CITY OF ALBUQUERQUE

RE: **Lot 19 Unser Cliffs**
6823 Rimrock Cir. NW
Grading and Drainage Plan
Engineers Stamp Date 9/6/2021 (D10D024)
Pad Certification Date 5/26/2022

Based upon the information provided in your submittal received 5/27/2022, this plan is approved for Building Permit by Hydrology

ENGINEER'S SEAL	6823 RIMROCK	DRAWN BY WCVJ
		DATE 9-02-21
	GRADING AND DRAINAGE PLAN	210210083-LAYOUT-8-02-21
9/6/21	 <i>Rio Grande Engineering</i> 1606 CENTRAL AVENUE SE SUITE 201 ALBUQUERQUE, NM 87106 (505) 872-0999	SHEET # —
DAVID SOULE P.E. #14522		JOB # 21021083

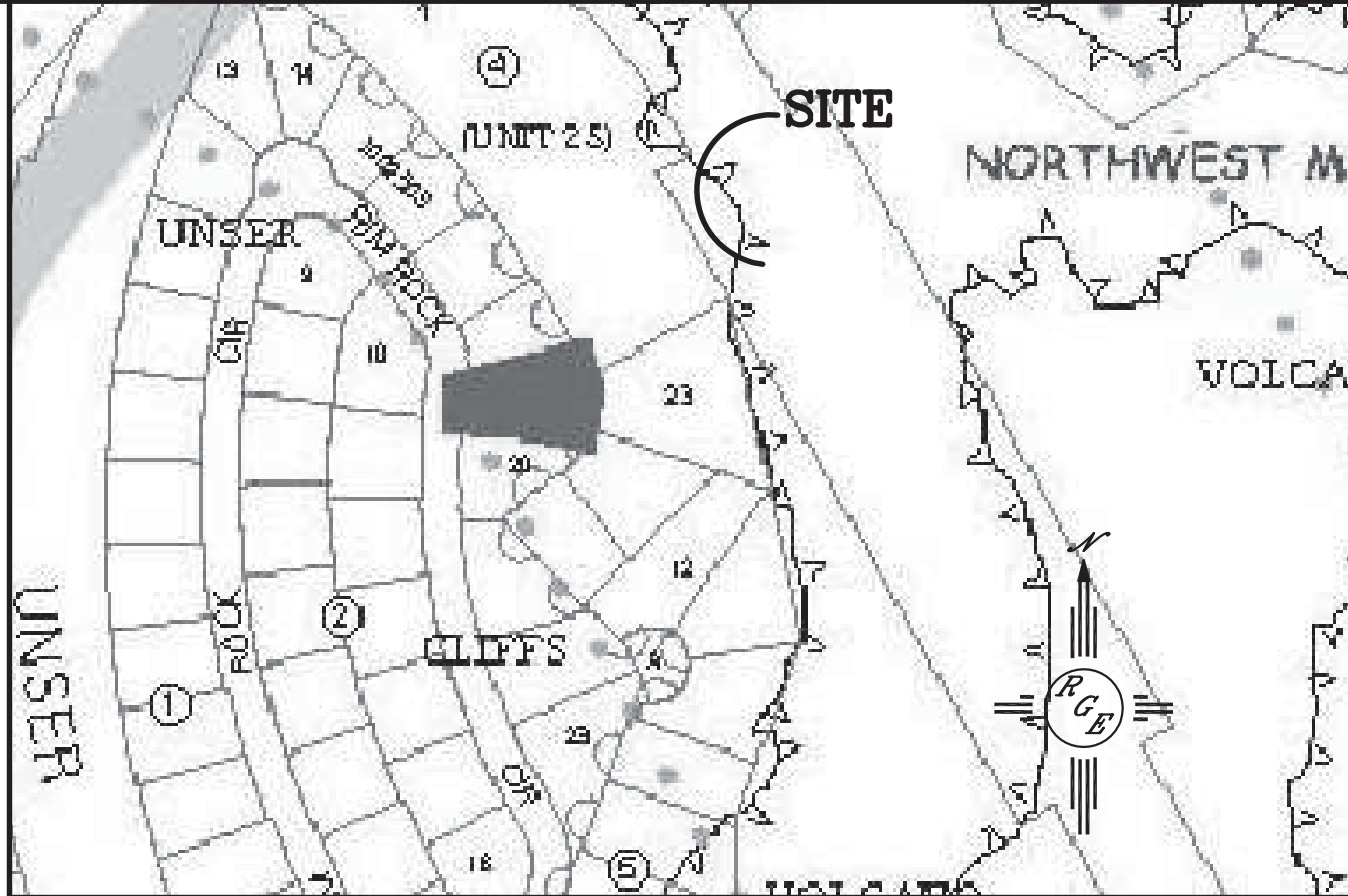
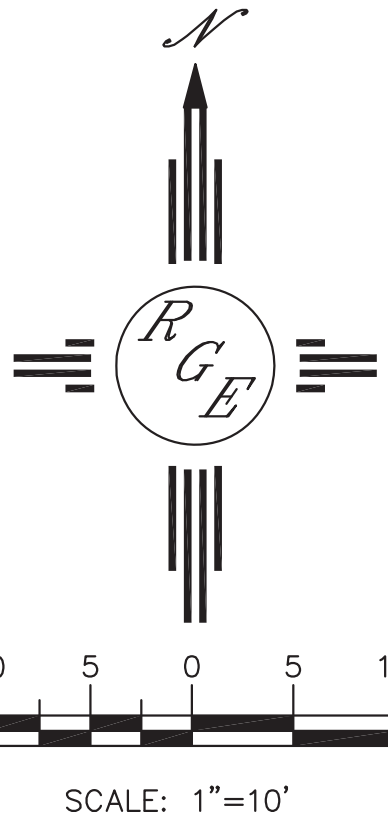
Reiterate to the Owner/Contractor that a separate permit for a garden/retaining wall must be obtained, with the approved G&D plan and Pad Certification. Also, let the owner/contractor know that if a pool is to be added in the future the G&D plan will need to be modified showing the location of the pool and the land treatment differences. Also advise the owner & Contractor that dirt is not allowed in the public right of way to climb the curb. Crusher fines or lumber is allowed. If dirt is used this will delay going forward with the construction of the home.

Prior to Certificate of Occupancy release, Engineer Certification per the DPM checklist of this plan will be required.
